Perth and Kinross Council
Development Management Committee – 16 July 2014
Report of Handling by Development Quality Manager

Erection of a dwellinghouse at Causeway Cottage, Scotlandwell, Kinross

Ref. No: 09/00936/FLL
Ward No: 8 Kinross-shire

Figure 3

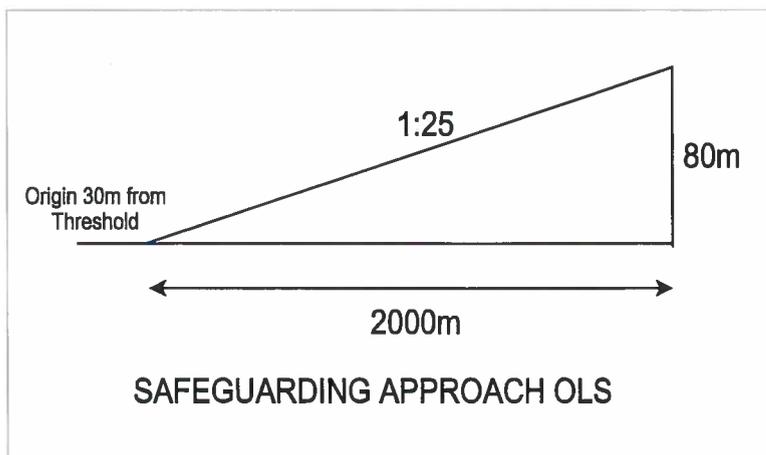
15. At Para 5, it is shown that the guidance of CAPs 168 and 738 should be used to safeguard Portmoak's flying operations. Using Code 1 visual runway parameters, the origin of the approach (APPS) obstacle limitation surface (OLS) will be positioned 30m before the NT. However, with a shallower approach angle than is catered for by code 1 parameters, the protective APPS slope is reduced to 1:25 to give a necessary safety buffer. The profile of the APPS is shown at Figure 3.

16. A slope of 1:25 equates to 2.3° . (The takeoff and climb OLS (TOCS) has a slope of 1:20 or 2.86° .) The photograph at A3 is taken at approximately 40m from the Eastern boundary, facing East. Using Ordnance Survey digital terrain elevation data (OSDTED) the average ground elevation data along the NT immediately to the West of the site is 108mAOD. The elevation of the origin of APPS would therefore be 108mAOD. Survey would be necessary to determine precise elevations.

Figure 4

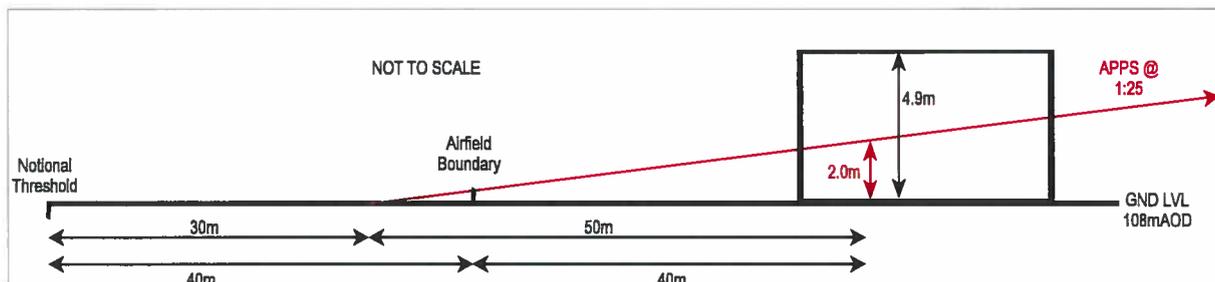
19. From the elevations of the building plans it would appear that the ridge the highest point, shown at 4.9mAGL. From the site plan, it would appear that the ridge lies 40m from the airfield boundary, perpendicular to it. This equates to 80m from the NT and 50m from the origin of the APPS. See Figure 4.

$$\text{Or } 50 \div 25 = 2.0\text{mAGL}$$

21. Thus, any structure exceeding 2.0mAGL at the proposed position will infringe the safeguarding approach OLS. At a stated height of 4.9mAGL the proposed building would infringe the APPS by 2.9m, illustrated at Figure 4.

Figure 5.1: Cumulative number of undershoots as a function of year

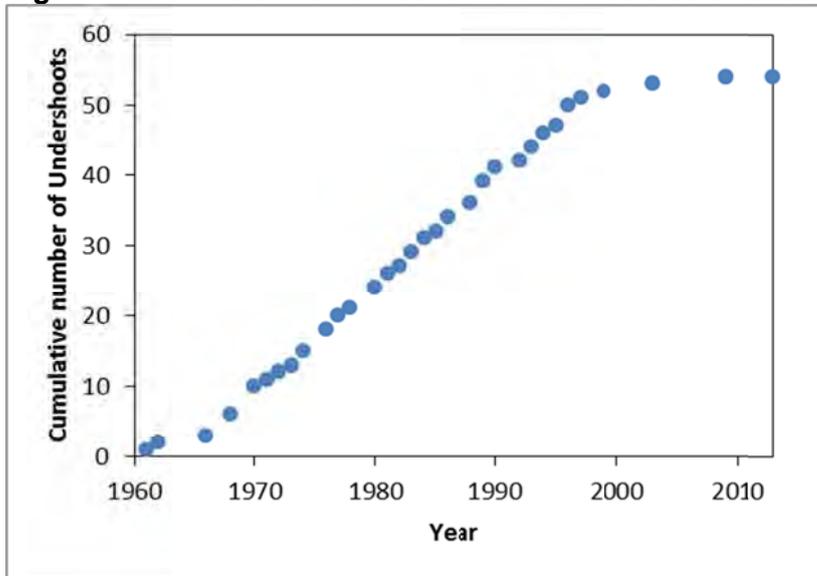
is evident from the graph of the cumulative number of incidents with time shown in Figure 5.1. The graph shows that the number of incidents increased fairly steadily from 1961 to 1996 with three undershoots occurring to the last year of this period: a steady increase in the cumulative number of incidents with time indicates a constant annual rate. In the 17 year period from 1997 to 2013, there have been four events, providing an estimated rate of 0.235 per annum.

- 5.14 Incident rate estimates based on small numbers of incidents will have a limited statistically reliable. Standard practice in these circumstances is to apply Poisson statistics to take account of the uncertainty associated with the small data sample. Based on the observed value, this approach provides an estimate of the probability of the “true” value lying within a defined range. Based on the time periods over which the last two, three and four incidents occurred, 95% upper confidence limit estimates in the range of 0.54 and 0.6 per annum are estimated: i.e. there is a 95% chance of the “true” rate not being more than these values. These cautious estimates of the recent rate represent a reduction by around a factor of two and a half compared with the historical rate for 1961 to 1999. The 50% confidence limit estimates of the “true” value lie in the range of 0.24 to 0.28 per annum, representing a reduction of around a factor of five. On that basis, it may be concluded there has been a statistically significant reduction in the incident rate in recent years. In assessments of this sort it is normal practice to err on the side of caution and adopt the 95% confidence limit value, whilst recognising that this is likely to be pessimistic. Applying that annual rate and applying the factors identified earlier in respect of the probability of the incident involving collision with the proposed new house, a 95% confidence limit estimate for the current collision rate of 1 in 190 years is derived, which compares with the 50% confidence limit estimate of 1 in 372 years.

Figure 5.2: Safeguarding surface option profiles

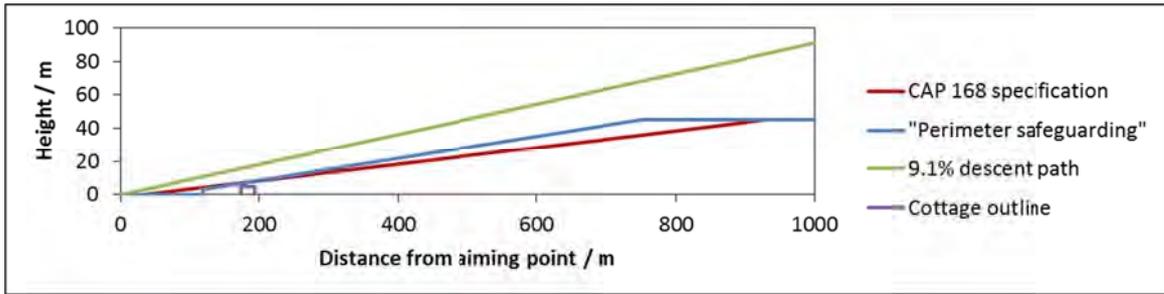
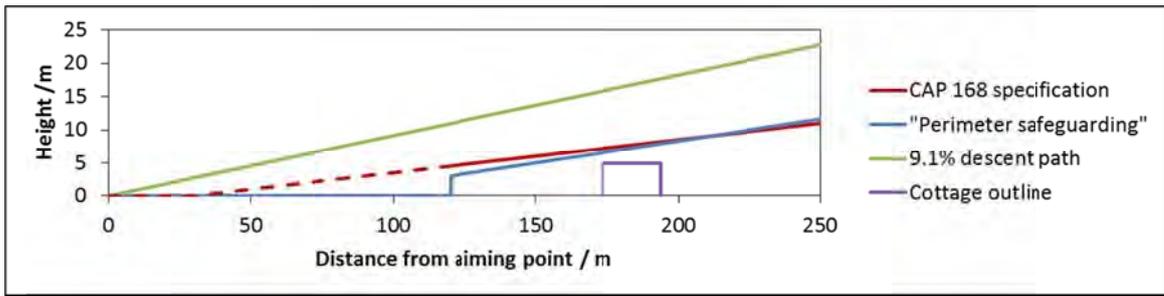
- 5.37 Aiming further into the airfield would inevitably reduce the extent of the obstacle restriction at the airfield boundary and beyond. The proposed Causeway Cottage would not be a penetration of the approach surface according to the CAP 168 specification which takes account of the RESA requirements. It is instructive to consider these implications further in relation to both the CAP 168 specification and the perimeter safeguarding surface approach proposed in the Hedge Report. The respective height restrictions for these two specifications are shown schematically in Figure 5.2. It can be seen that the height restrictions associated with the CAP 168 specification are less demanding at the airfield boundary and at the Causeway Cottage location. Given the greater slope of 1 in 15 adopted in the perimeter safeguarding surface approach compared with the CAP 168 slope of 1 in 20 the former approach becomes less restrictive at distances further from the airfield. There is evidently not much difference between the restrictions associated with the two options over the Causeway Cottage site but the vertical clearance margin would be reduced from about 32.5 m to 23.5 m compared with the 9.1% descent path at the point where the 45 m horizontal surface becomes limiting.

- 5.38 The conclusion reached in this assessment is therefore that the locations of the notional runway thresholds shown in the SGU safeguarding document that are employed as the basis for the approach surface specification are inappropriate since they fail to provide adequate undershoot provision within the airfield boundary. If adequate provision for undershoot were to be made the origin of the approach surface would be relocated such that the Causeway Cottage would not be a penetration of the surface. In operational terms, if a more appropriate aiming point within the airfield were to be adopted then the vertical margin with respect to the cottage at a height of 4.9 m would be more than the minimum prescribed in CAP 168 and could therefore be expected to be adequate.
